Amendment No. 1
to
AS/NZS 2381.2:2006
Electrical equipment for explosive atmospheres—Selection, installation and maintenance
Part 2: Flameproof enclosure ‘d’

CORRECTION

SUMMARY: This Amendment applies to the Figure 3.1.

Page 11 Figure 3.1

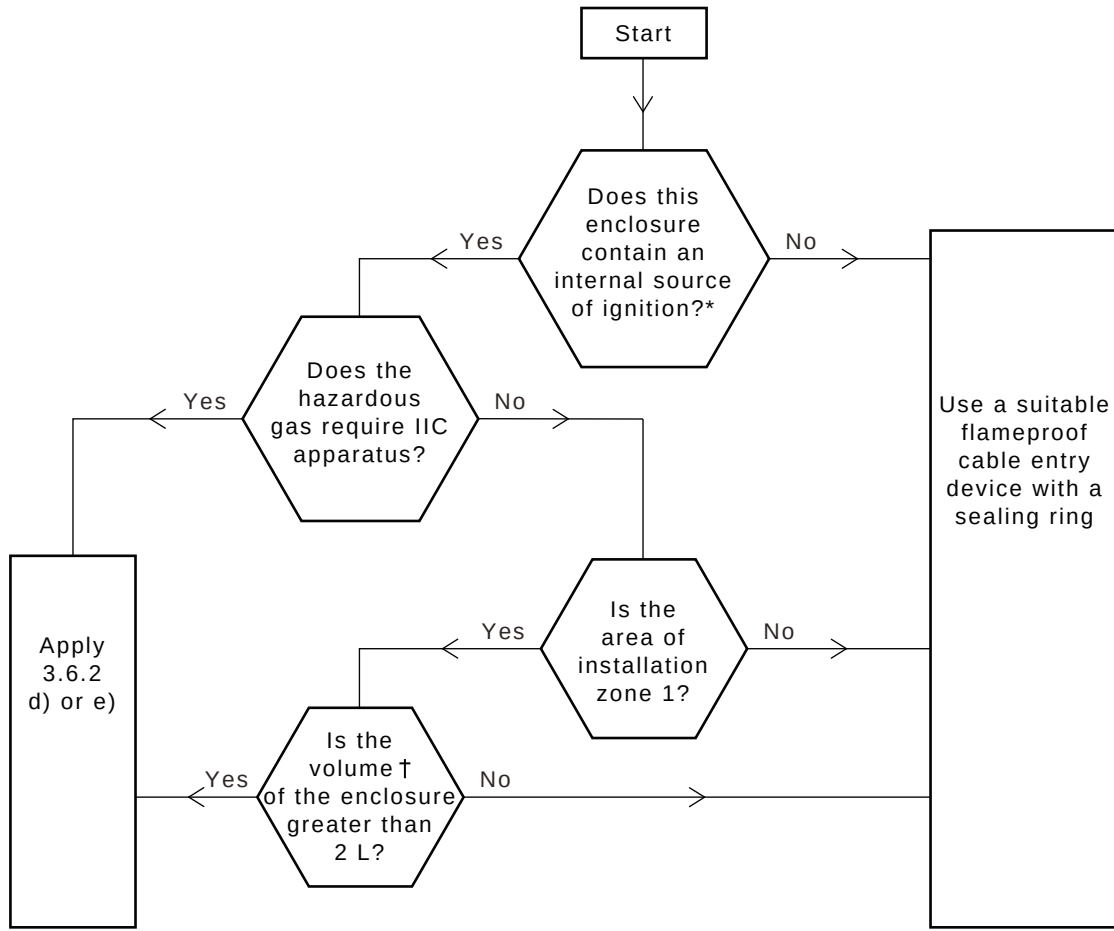
Delete the existing figure and replace with the following:

* Internal sources of ignition include sparks or equipment temperature occurring in normal operation which can cause ignition. An enclosure containing terminals only or an indirect entry enclosure (see Clause 3.6.2) is considered not to constitute an internal source of ignition.

† The term 'volume' is defined in AS/NZS 60079.1.
